N&W GLOBAL VENDING

TYPE NO **ES 5100**	TYPE **Espresso machine**	T.I.-NO **ES5100 2006-01**
SERIAL NUMBERS AFFECTED	**See below**	ISSUED BY **Documentation/ Wittenborg Odense**
SUBJECT	**New dispensing valves and angle union (new supplier)**	ISSUED FOR (X): Action Information x

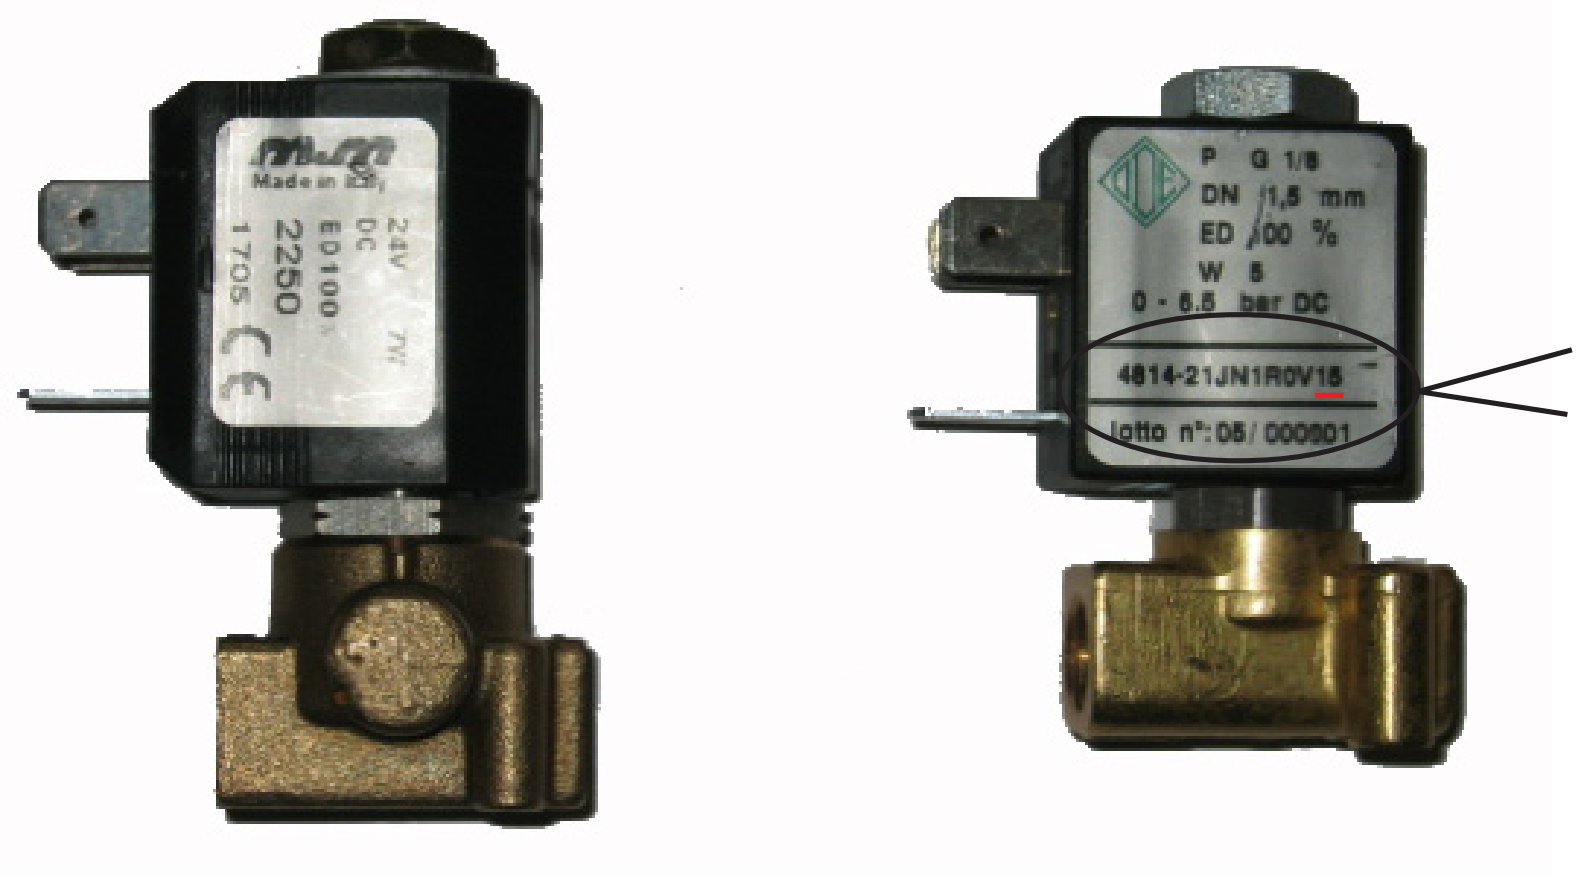
- In ES5100 machines from serial number 582529, the dispensing valve 1/8"-1.5 mm, part number 41532003, has been replaced by an outlet valve of a new make, ODE. The part number remains the same.

The dispensing valve 1/8" - 2.0 mm, part number 41532005, will be replaced by an outlet valve of a new make, ODE in all ES5100 machines produced in approximately week 14-2006. The part number remains the same.

The hexagon nut, part number 09102710 is omitted.

OLD MAKE
MM

NEW MAKE
ODE

- The changed outlet valves, part numbers 41532003 and 41532005 replace the previous ones directly. As the threading design of the water inlet on the changed valves has changed into a conical shaped at the bottom, the hexagon nut part number 09102710 is no longer needed as a spacer, and is thus omitted.
